ADDENDUM No. 2

Date December 8, 2015

Project Name Davis Water Treatment Plant Treated Water Discharge System

C.I.P. No. 2015.041

DAVIS WATER TREATMENT PLANT
TREATED WATER DISCHARGE SYSTEM
CIP PROJECT No. 2015.041
MEDIUM SERVICE PUMP STATION
MSPS-MSP-001 PUMPING UNIT
CONTROL WIRING SCHEMATIC (SHEET 3 OF 3)

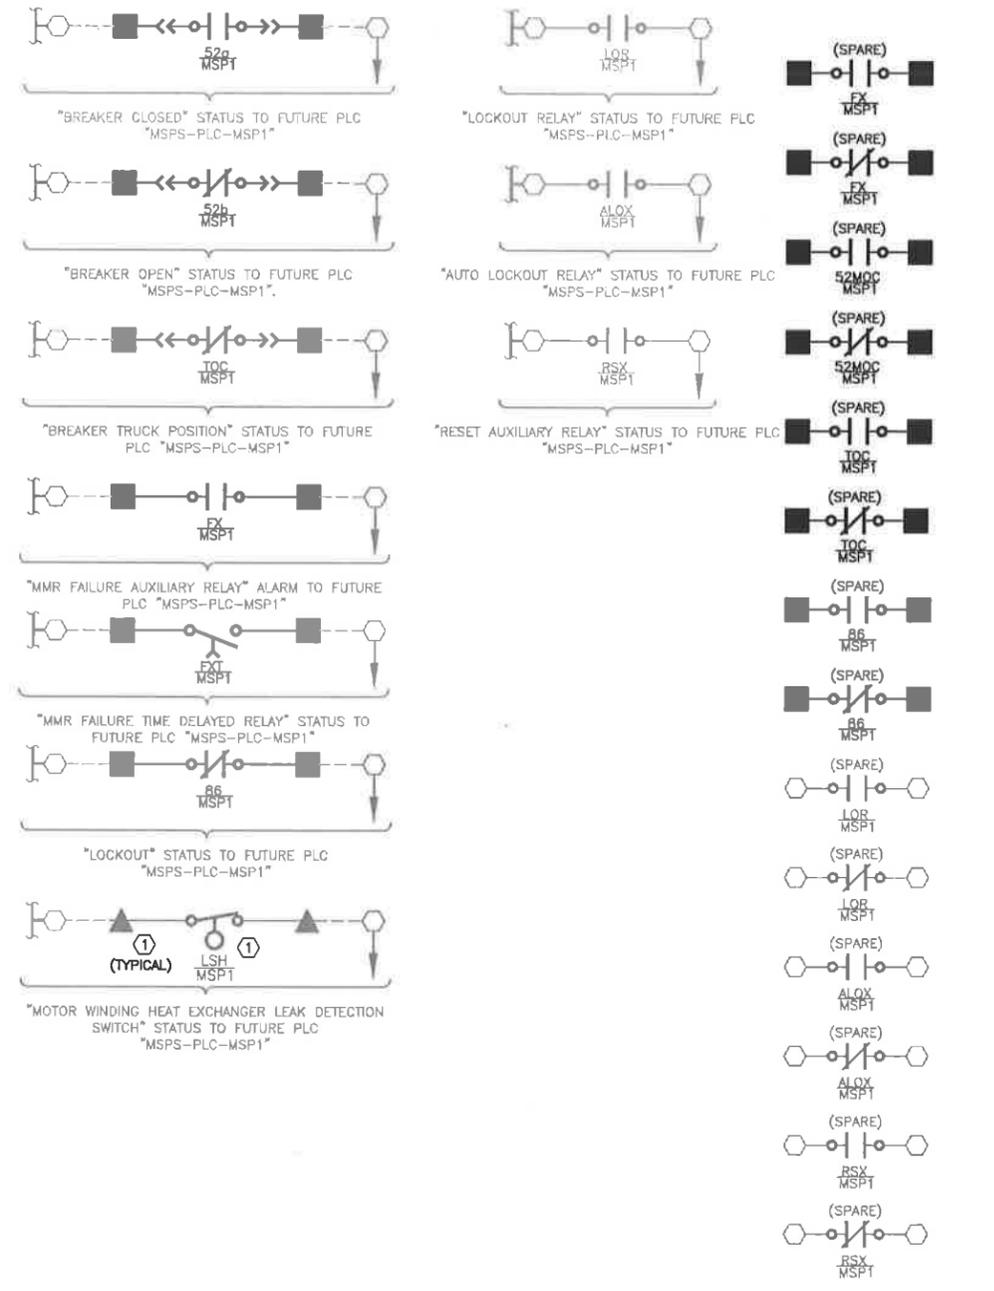
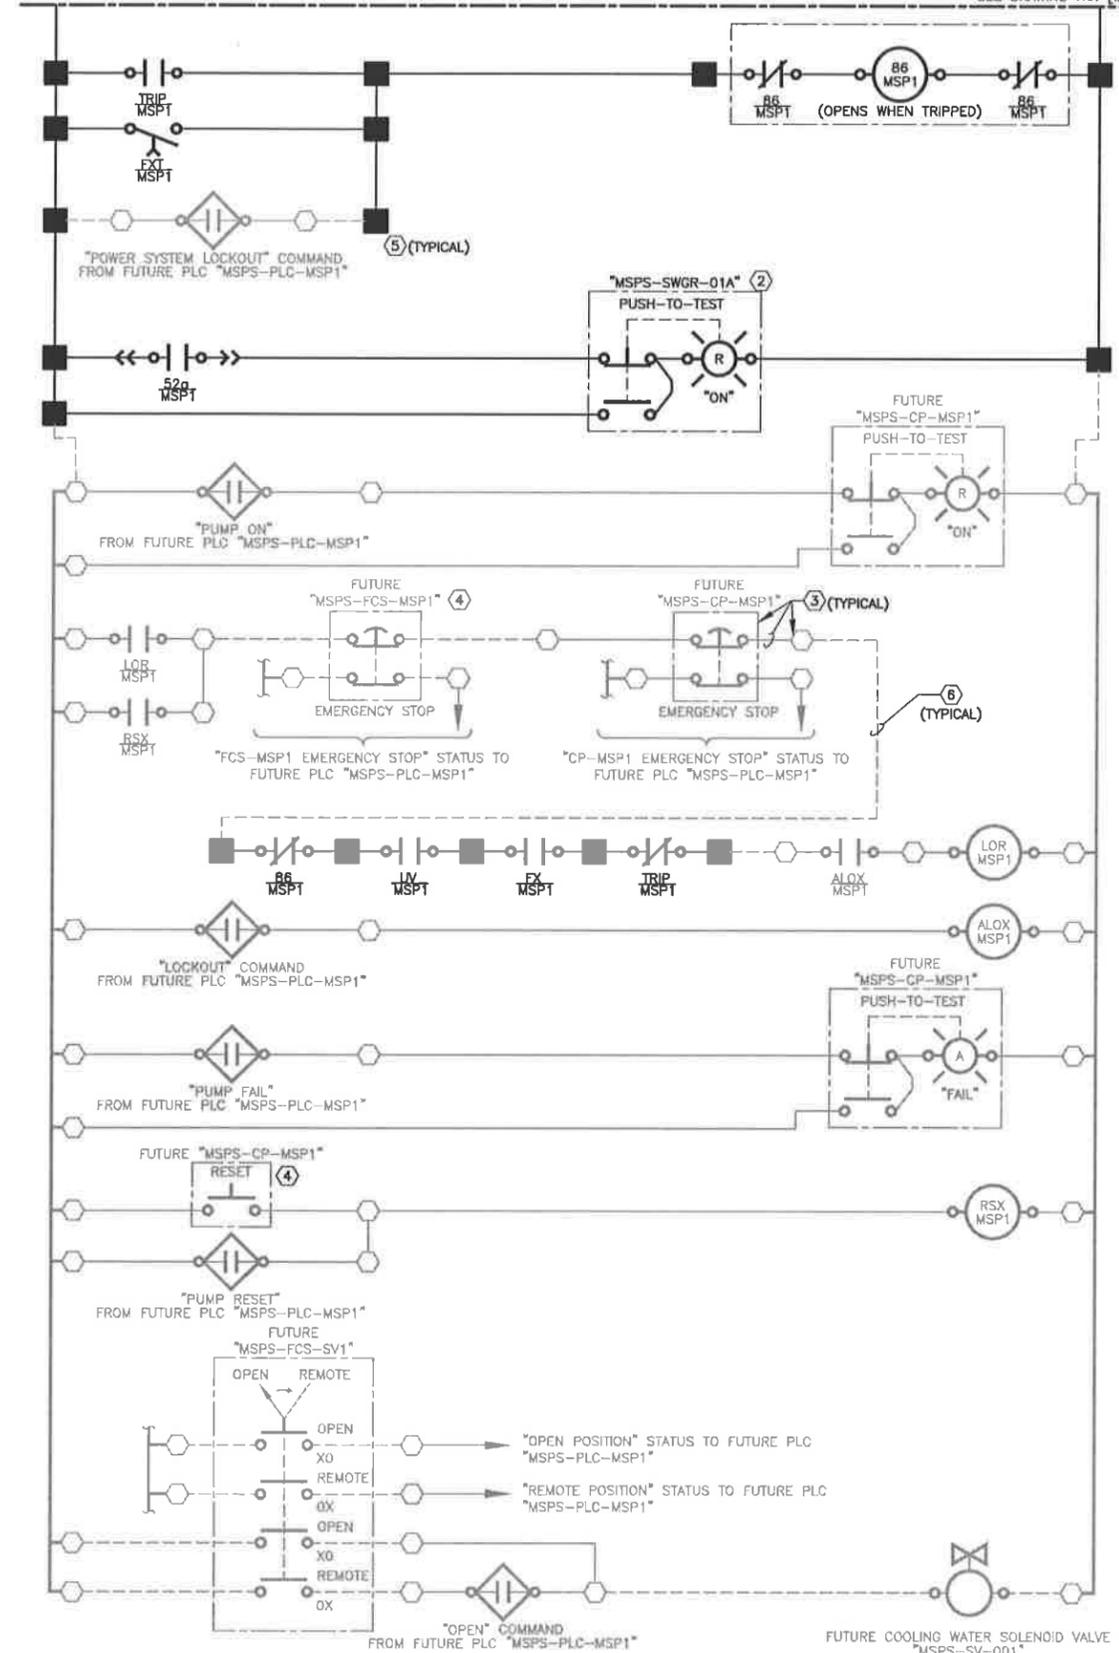
1. Replace drawing MSPS-M-25 with the attached revised drawing.
2. Include attached drawing MSPS-E-70 as part of the bid package.
3. Replace drawing MSPS-I-45 with the attached revised drawing.
4. Replace drawing TD-E-1 with the attached revised drawing.
